Product Update Memo

INDUCTIVE COMPONENTS

March, 2015

Data Sheet Correction to Solder Terminal Dimension for SRP1265(A) Shielded Power Inductor Series

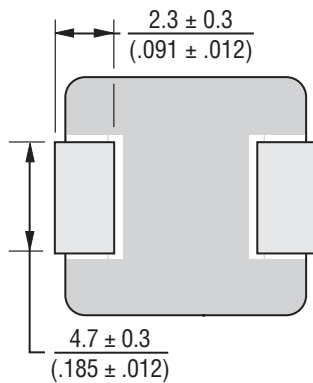
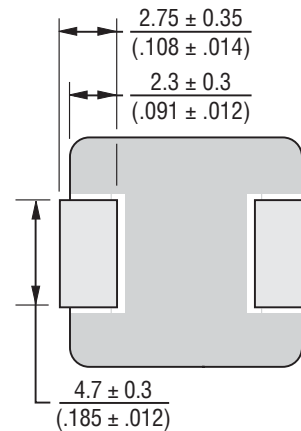
Recently, an error has been discovered in the solder terminal dimension of the [Model SRP1265\(A\)](#) data sheet drawings. The erroneous dimension (*Figure 1*) has been corrected (*Figure 2*).

The solder terminals of these two series have been manufactured to the *Figure 2* dimension since the inception of these inductors. This data sheet correction for Model SRP1265(A) has no impact to the form, fit, function and quality of the components.
